Comment/Responses
PPL Montana Colstrip Steam Electric Station
Administrative Order on Consent Plant Site Report
(Plant Site Characterization Report)

Conditional Acceptance by Montana Department of Environmental Quality
September 5, 2014

DEQ conditionally approves the Plant Site Report provided the following revisions to the report are made to satisfaction of DEQ.

b. Second bullet

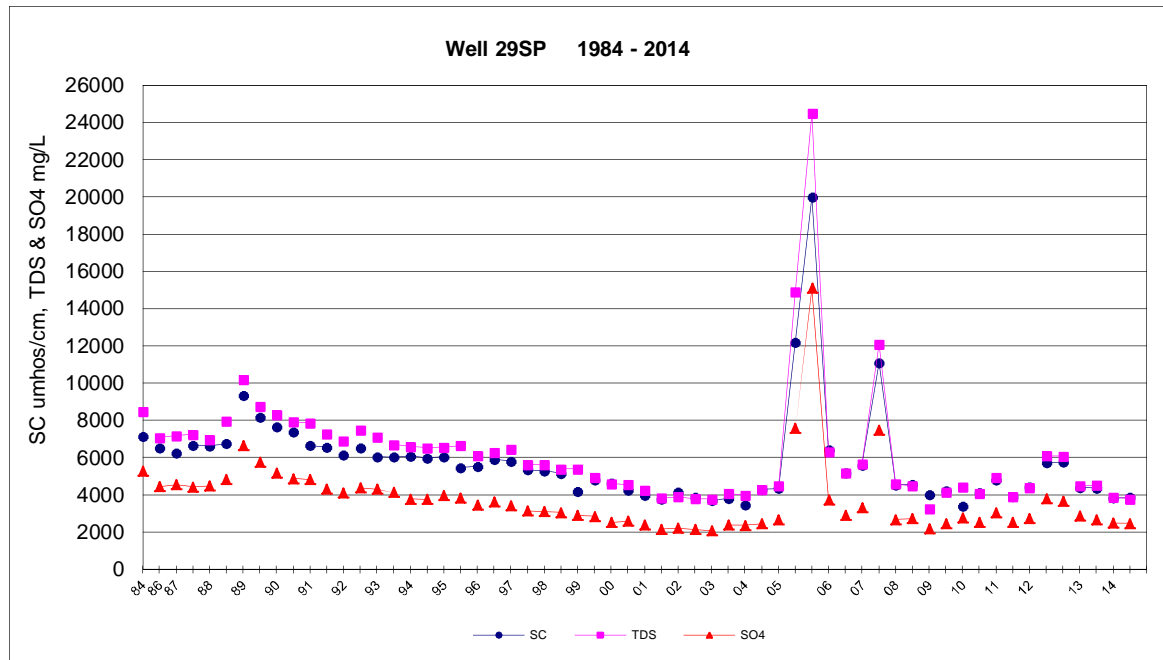
Please change the names so as to be consistent with Figure 2-1, and in Table 2-1.

DEQ requests that PPLM explain to what depth were the solids removed from “below the former D4 Brine Pond”. Please explain the criteria used to assess how much material was removed (both surficial area and depth), which areas were excavated, and which areas were not excavated.

Please specify what “field operations” were conducted by PPLM that found evidence for elevated salts in the soil. Please summarize the evidence from specific wells that “soil containing elevated levels of salt remains in the area”. Please summarize the evidence that the previously mentioned specific wells were not impacted by process pond water from neighboring areas with slurry-filled ponds as compared to leaching from salt-laden soils in the Brine Pond area.

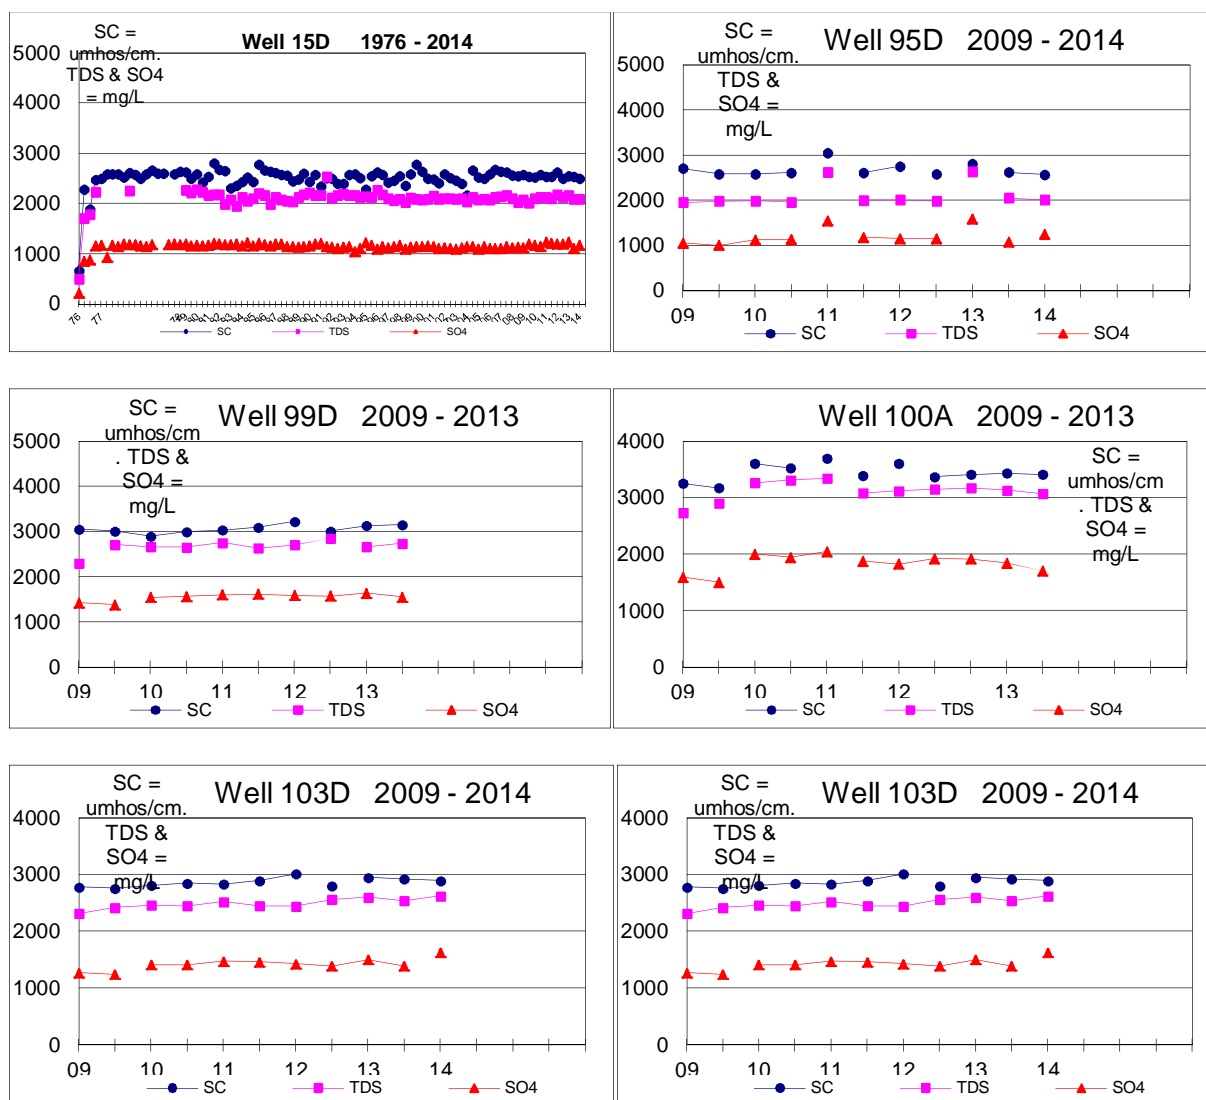
1. DEQ is unsure if the subareas described in the subsections of Section 3.6 fully cover the extent of the Plant Site Area. Areas that may not be included in the discussion are: 1) the area near the four boiler units, with the 800-series wells and “U” wells; 2) the area north of the four units across the road near the North Pond (wells 23S, 23M, and 24S); 3) the area north of the Units 1 & 2 A/B Flyash Pond including the Units 1 & 2 Bottom Ash Clearwell and Sediment Retention Pond and wells such as SRP-1, 42S, 49S, 46A, 78a, 77D, 76A, 30S-2, and AB12-S; 4) the area furthest west of the Units 1 & 2 Flyash Pond A Side (wells located in the town of Colstrip and near East Fork Armells Creek) including wells such as 15D, 15 S, 95A, 95D, 00A, 99D, 103D, 104A, CA-18, and 101A; 5) the “P” wells located in the extreme southwest of the Plant Site Area near East Fork Armells Creek; 6) the area located west and southwest of the Cooling Tower Blowdown Ponds C including wells such as 127M, 127R, 39M, 39S, 69R, 14M, 61M, 62S, 67M, 68A, 129D, 130M, 10S, and 10M. If these areas are parts of the subareas described in the subsections, please include these areas in the effectiveness assessments in the appropriate subsections.

Response: Responses are as listed per each numbered item under Comment 9. Note that the referenced section is titled Effectiveness Assessment of Remedial Action.

9,1). A “sub-area” was not discussed since this area, referred to as the “800-Series” well area is administrated under the Montana Department of Environmental Quality Petroleum Tank Cleanup Program. This area is impacted from turbine oil, diesel fuel, and gasoline from past spills and is not a part of the AOC. Note that sulfate and boron levels have been detected at well 811 in concentrations above the BSL for alluvium.

9,2). The area around the Units 3&4 North Plant Area Drain Pond (North Pond) has not shownd definitive indicators of process water and text describing the water quality conditions in this area was not included. Note that concentrations of boron and chloride have exceeded BSL levels, which are under review as of Octover 2014, No remediation is ongoing in this area but groundwater monitoring continues in this area.

9,3). The wells listed (SRP-1, 42S, 49S, 46A, 78a, 77D, 76A, 30S-2, and AB12-S) ;are within the area identified in Section 3.5 (formerly Section 3.6) as the Northwest area. A water quality trend graph for 49S is on former Figure 3-15 (now 3-27).

9,4). The area containing wells 15D, 15S, 95A, 95D, (1?)00A, 99D, 103D, 104A, CA-18, and 101A is described in Units 1&2 A/B Flyash Pond Area (former section 3.6.4, now Section 3.5.4). The wells listed in Figure 3-26,(formerly 3-14) include representative graphs for a variety of wells in this area. Data spreadsheets containing graphs for all the mentioned wells have been submitted to MDEQ in the form of database files with the annual reports and indepently as Excel spreadsheets following requests for the information. Further discusion has been added to the revised text for this area to further address some of the information requested. Water quality

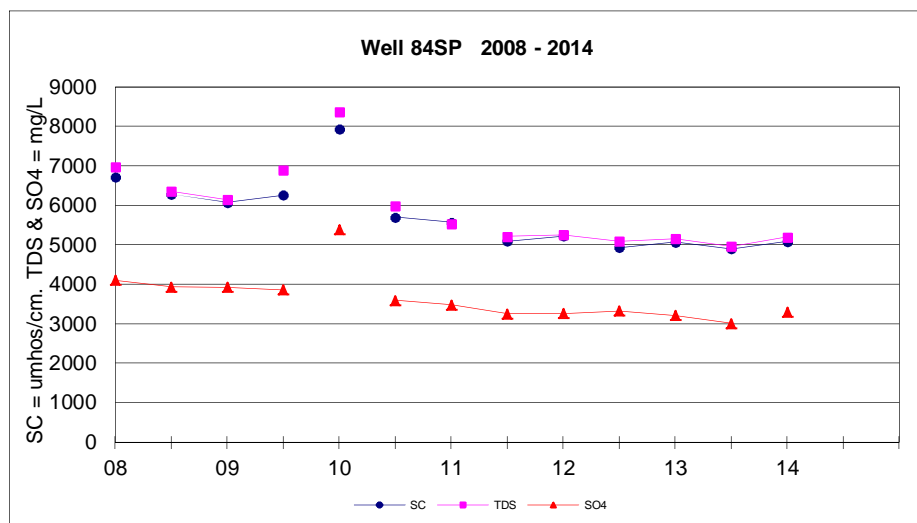
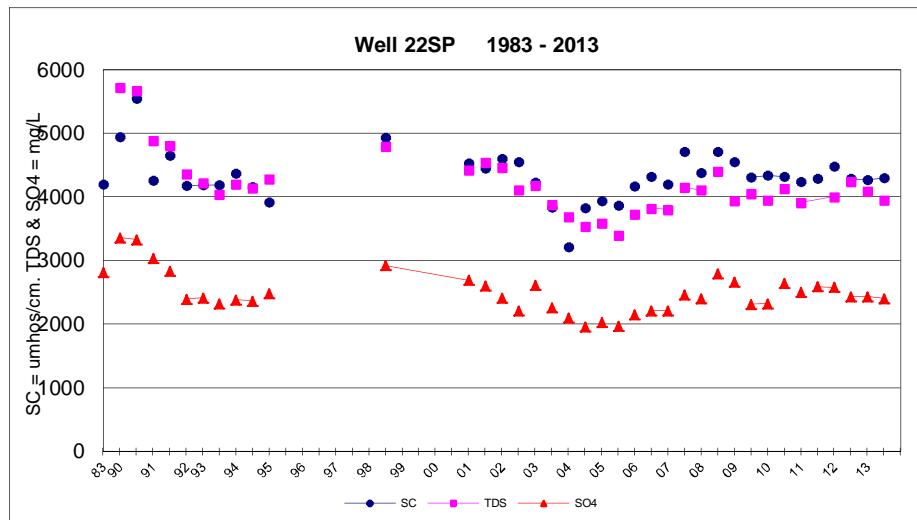
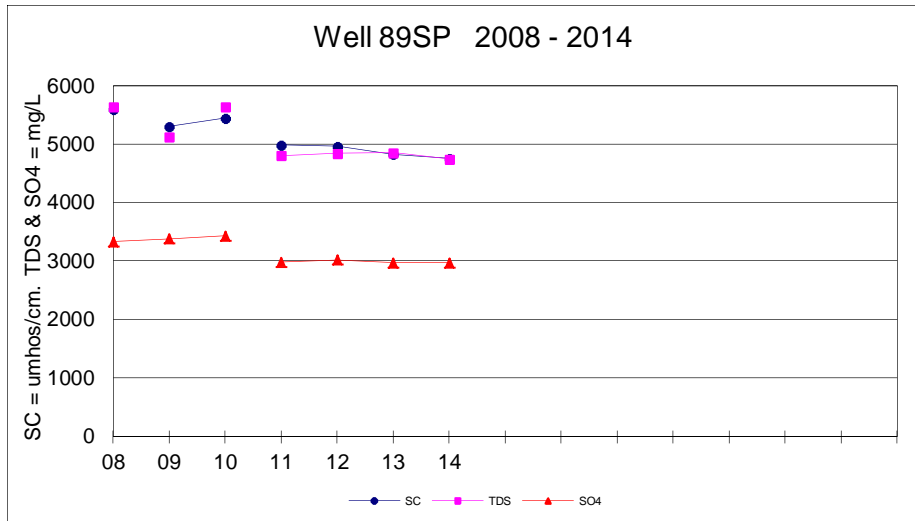
All of the indicator parameter trends shown in Figure 3-12 are for wells installed south and southeast of the ponds. Please describe the trends observed in the monitoring wells located north and west of the ponds. If the same trends observed in the southern monitoring wells 20M and 20SP are observed in the western and northern monitoring wells, please state this.

Please discuss how the pond mitigation measures completed in this subarea have impacted water quality in surrounding wells. Specifically please comment on the effect of relining the Units 3 & 4 Bottom Ash Ponds with clay in 1991.

Compared to the pumping rates of other capture wells in this subarea (4.1 to 0.2 gpm), the pumping rate of the WECO well is very large (54.9 gpm). The WECO well is located north of the ponds (approximately 400-500 feet north of the nearest pond). The other capture wells are south of the ponds; the wells closest to the ponds are 60-80 feet south of the southernmost pond. The pumping of the WECO was modeled in the 2012 groundwater report; however there is no documentation in the capture zone analysis to compare the capture zone size of the WECO well with the other wells. DEQ requests that PPL comment on the relative effect of different capture zones as possibly being the reason that water quality has not

apparently improved in this subarea. Please also compare the water quality data of the WECO well to those of the other capture wells.

Response: Comment 15 paragraph 1, 2 & 3 - A figure has been added to the report showing the approximate area described as the Units 3&4 Bottom Ash Ponds in former Section 3.6.2 and former Section 3.6.3 Former Brine Pond Area. Well locations and groundwater flow directions are shown on the figure.
